D. PETWAY SUBDIVISION

Revised for the April 1, 2010 meeting

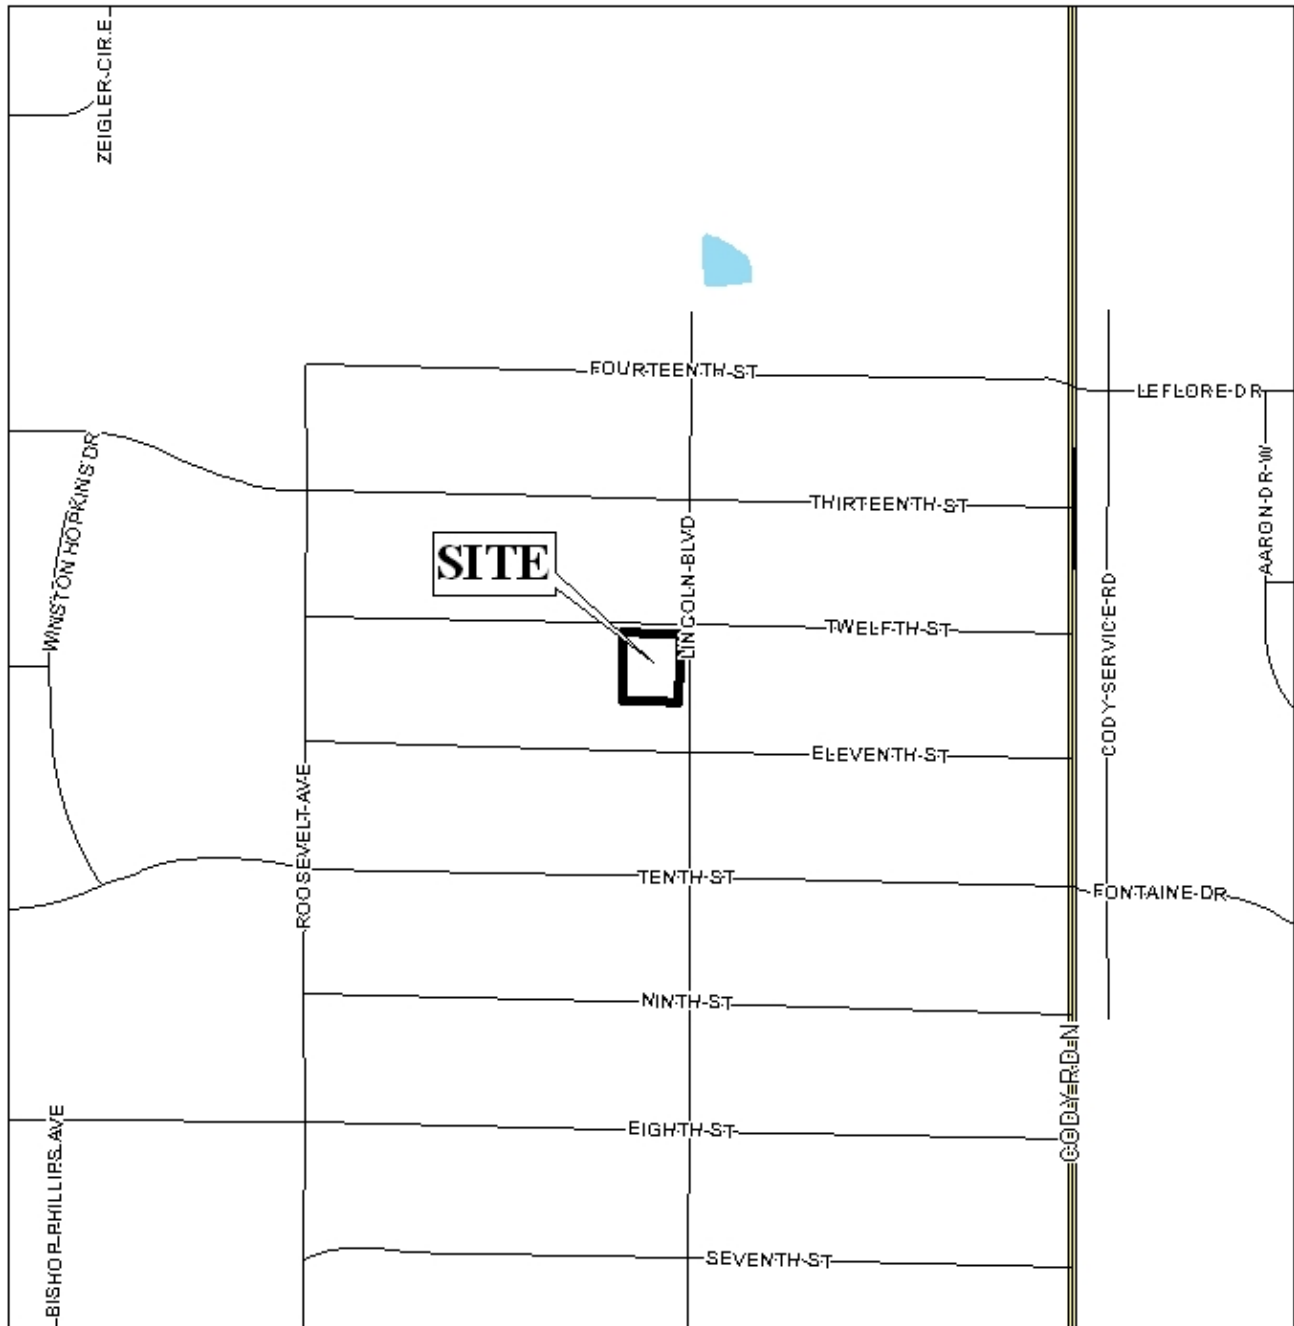
The proposed lot, as depicted, meets the minimum size and frontage requirements as regulated by the Subdivision Regulations. The lot area size is depicted on the plat, and this information should be retained on the final plat, if approved.

The 25-foot minimum building setback line is not depicted on the preliminary plat. The Final Plat should be revised to depict the 25-foot minimum building setback line along all rights-of-way, if approved.

The site fronts Lincoln Boulevard to the East and Twelfth Street to the North. Both streets are minor streets and are not provided with curb and gutter. Lincoln Boulevard is depicted with a right-of-way of 40 feet and Twelfth Street is depicted with a right-of-way of 30 feet. Section V.B.14 of the Subdivision Regulations requires minor streets not provided with curb and gutter to have a right-of-way of at least 60 feet. As such, dedication sufficient to provide 30 feet from the centerline of both Lincoln Boulevard and Twelfth Street should be required. Additionally, as this is a corner lot, compliance with Section V.B.16 of the Subdivision Regulations regarding curb radii should also be required. It should be noted that the 25-foot minimum building setback line should be depicted behind any required dedication.

The proposed lot is currently depicted as having two curb cuts to Lincoln Boulevard and no curb cuts to Twelfth Street. As such, the lot should be limited to the existing number of curb cuts,

with the size, design, and exact location of all curb cuts to be approved by Traffic Engineering and conform to AASHTO standards.

- 1) dedication sufficient to provide 30 feet from the centerline of Lincoln Boulevard and Twelfth Street;
- 2) compliance with Section V.B.16 of the Subdivision Regulations regarding curb radii;
- 3) placement of a note on the Final Plat stating that the site is limited to two curb cuts, with the size, design, and exact location of all curb cuts to be approved by Traffic Engineering and conform to AASHTO standards;
- 4) depiction of the 25-foot minimum building setback line along all street frontages;
- 5) retention of the lot size labeling, in square feet; and
- 6) placement of a note on the Final Plat stating that the site must be developed in compliance with all local, state and Federal regulations regarding endangered, threatened or otherwise protected species.
